Work Order ID 157365

Item ID: D3166-1 Accept ***N900040100*** Setup Start ***NS1***
Revision ID: Stop ***NS2***
Item Name: Basket Hoop
Start Date: 3/6/2017 Start Qty: 20.00 ***20*** Cust Item ID:
Required Date: 3/9/2017 Req'd Qty: 20.00 ***20*** Customer:
Reference: SCHEDULED

D3166-1 BASKET HOOP

DRAWING NO.	D3166	TITLE	BASKET HOOP	REV A1	DART AEROSPACE LTD		D.E.O. NO.	D3166-A-2	SHEET NO.	1 OF 1	SCALE	NTS
DRAWN	AJS	CHECKED		MFG. APPR.		APPROVED		DE APPR				
DATE	08.12.11	DATE	08.12.15	DATE	08/12/15	DATE	08/12/16	DATE	08.12.16

DESIGN	#	DRAWN BY	CP	DART AEROSPACE LTD HAWKESBURY, ONTARIO, CANADA	
CHECKED	#	APPROVED	#	DRAWING NO. D3166	REV. A SHEET 1 OF 1
DATE	02.07.10			TITLE BASKET HOOP	SCALE NTS
A	02.07.10			NEW ISSUE	
A1	04.04.08			38+/- 1 WAS 36.0

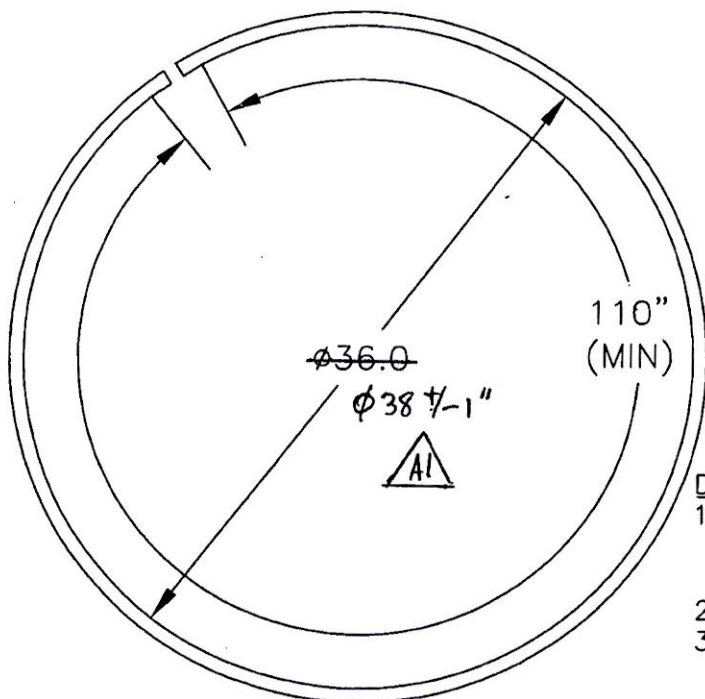
1) MODIFY MATERIAL NOTE FOR D3166-1 AS SHOWN:

1) MATERIAL: AISI 304/316 SS SQUARE TUBING,
0.75" X 0.75" X 0.063 WALL, 60.00" LONG
(REF DART SPEC. M304TS0.750W.063)

2) MODIFY MATERIAL NOTE FOR D3166-3 AS SHOWN:

1) MATERIAL: AISI 304/316 SS SQUARE TUBING,
0.75" X 0.75" X 0.063 WALL, 120.00" LONG
(REF DART SPEC. M304TS0.750W.063)

REASON: SEE PAR 08-005

IS:

1) MATERIAL: AISI 304/316 SS, 3/4 X 3/4 X 0.065 WALL SQUARE TUBING,
60.00" LONG

REF. DART SPEC M304TS0.750W.065

IS:

1) MATERIAL: AISI 304/316 SS, 3/4 X 3/4 X 0.065 WALL SQUARE TUBING,
120.00" LONG

REF. DART SPEC M304TS0.750W.065
